## Technical Bulletin

REFERENCE TB\_2022\_FRECA\_01\_EN

SUBJECT Update regulations

### Nomenclature (release 4.1.1)

#### 05A – Clutch Pedal

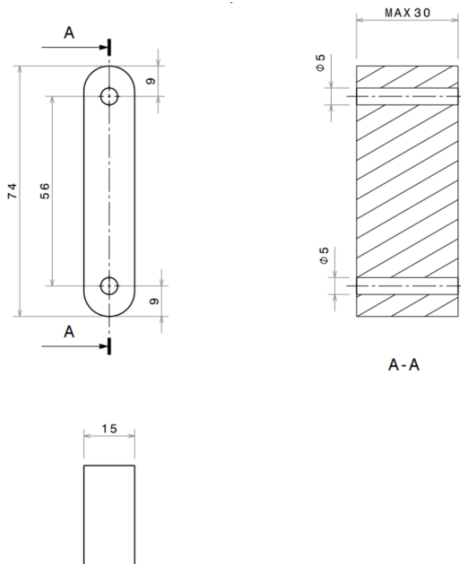
It is allowed to add spacers between the pedal and the pedal footplate.

The spacer must be aluminum. The maximum total thickness allowed is 30 mm.

**Important notice:** length of the bolts to install the pedal footplates shall be increased accordingly.

## 05B – Brake Pedal

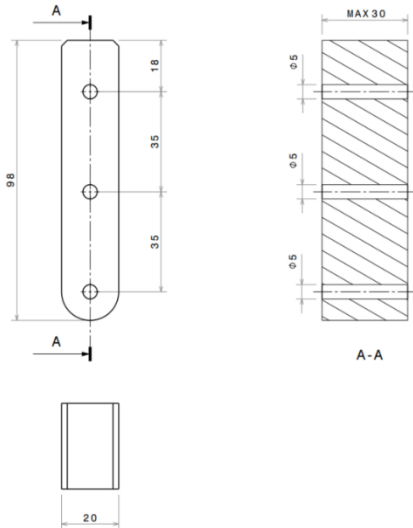
It is allowed to add spacers between the pedal and the pedal footplate.

The spacer must be aluminum. The maximum total thickness allowed is 30 mm.

**Important notice:** length of the bolts to install the pedal footplates shall be increased accordingly.

## 05C – Throttle Pedal

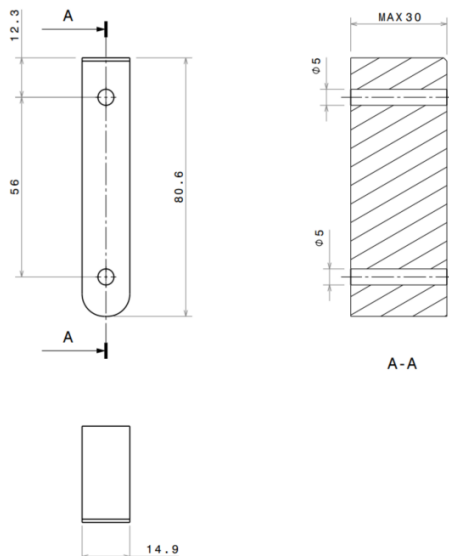
It is allowed to add spacers between the pedal and the pedal footplate.

The spacer must be aluminum. The maximum total thickness allowed is 30 mm.

**Important notice:** length of the bolts to install the pedal footplates shall be increased accordingly.

## Heel Rest

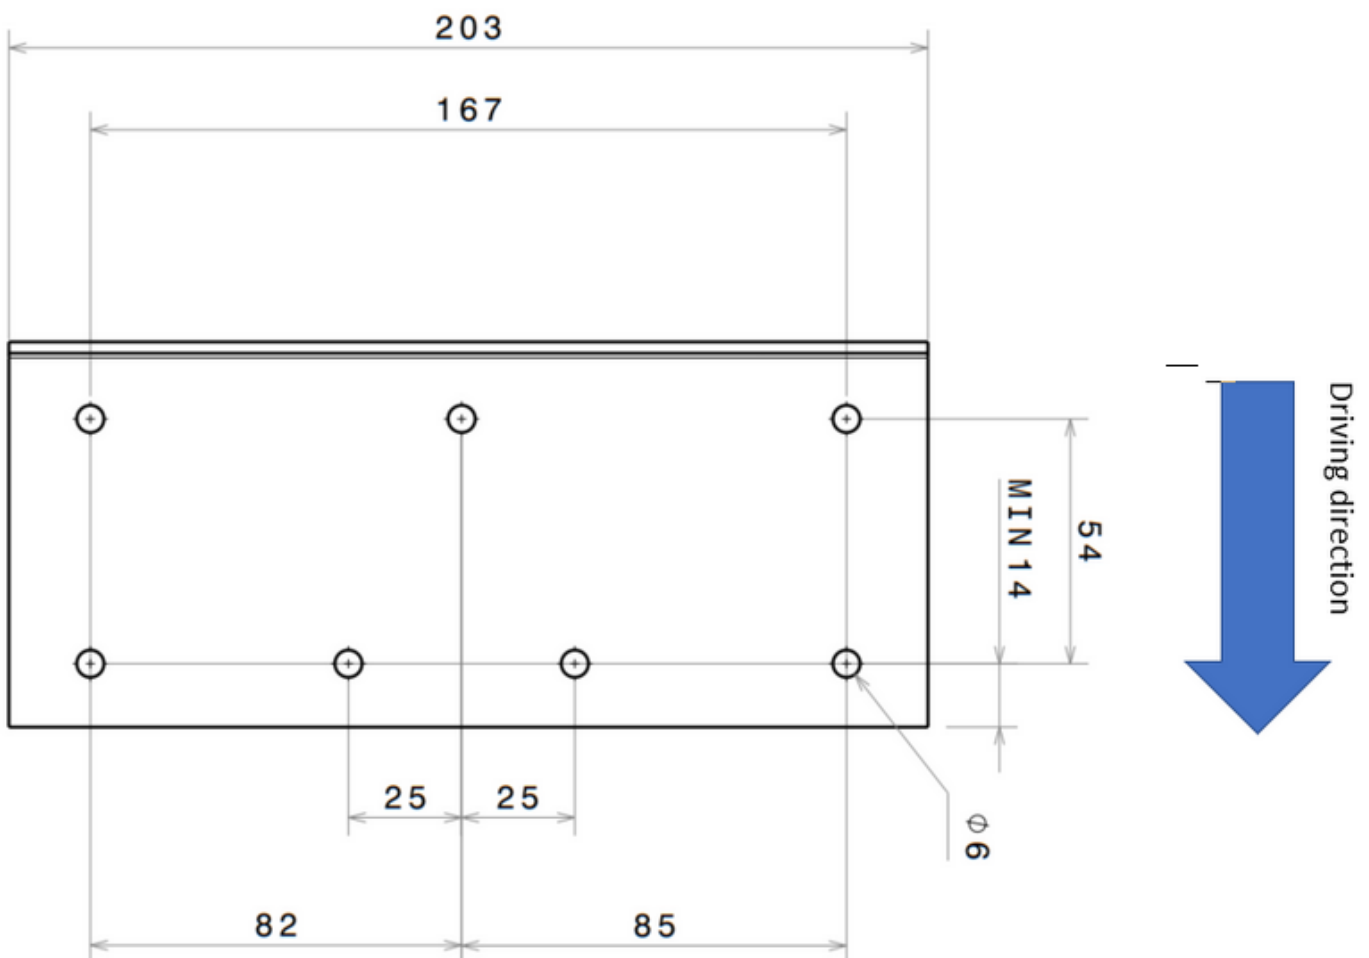
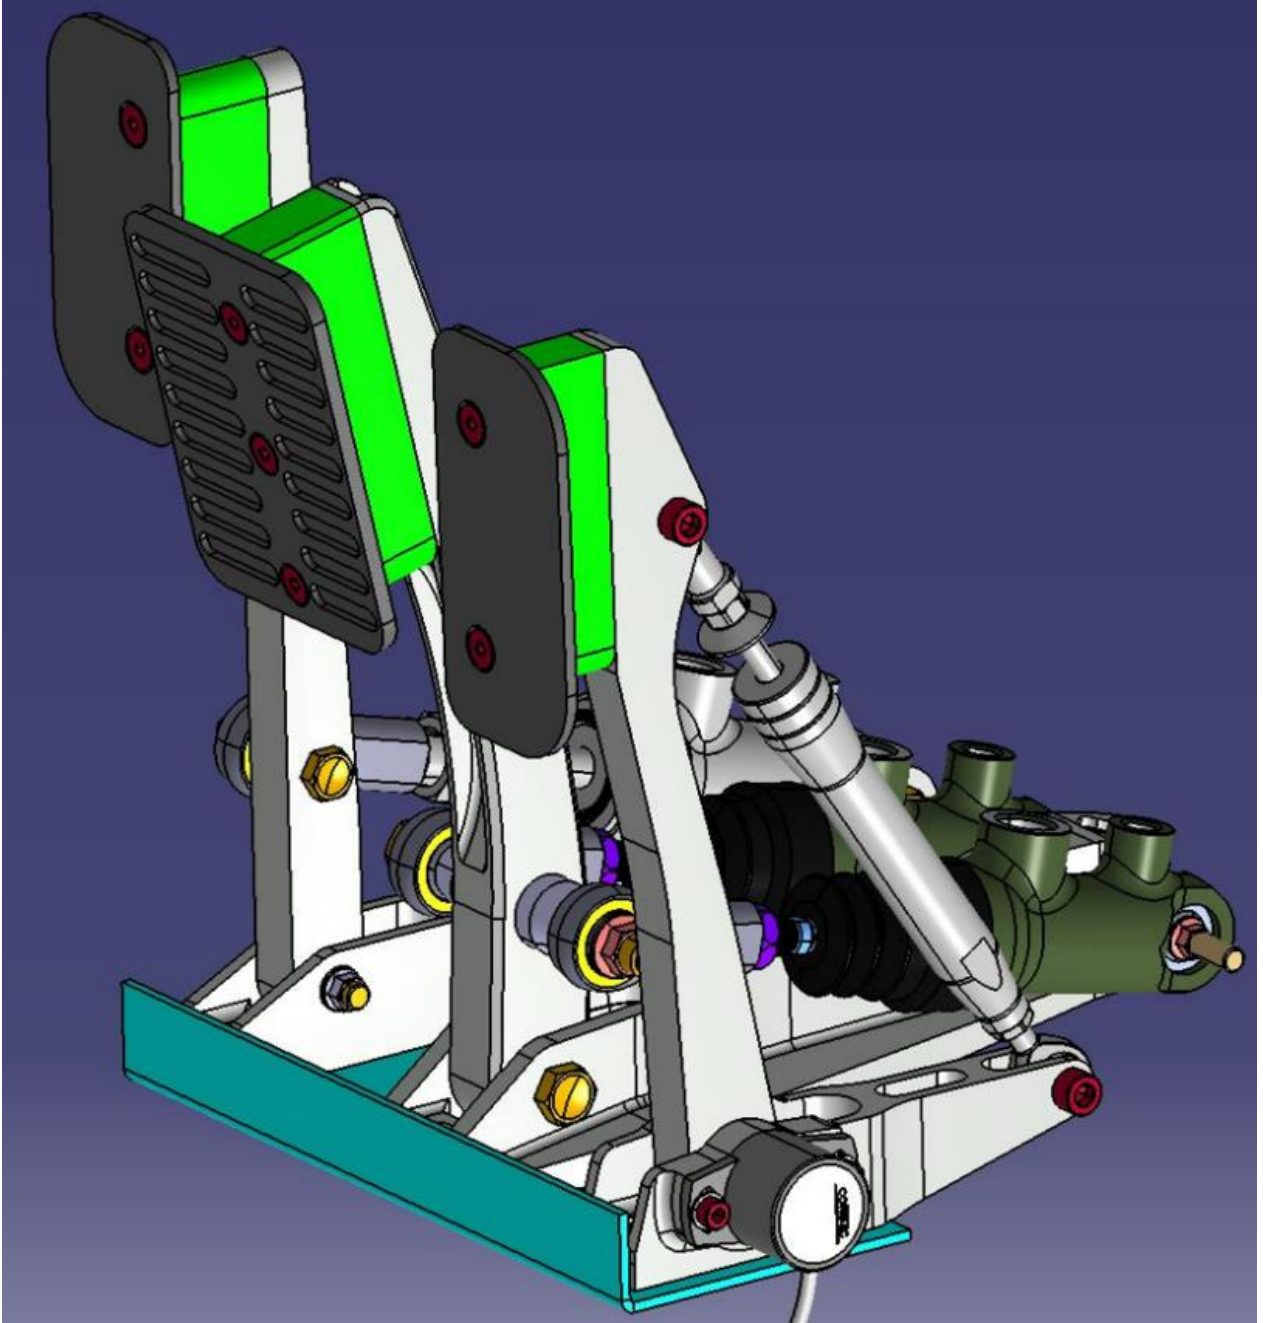
It is allowed to make a bolted heel rest on the same holes used to install the pedals, provided that the heel rest is held on all bolts of the pedals as shown in the reference drawing below.

Only aluminum or steel is allowed.

The maximum weight of the heel rest should not exceed **1 kilogram**.
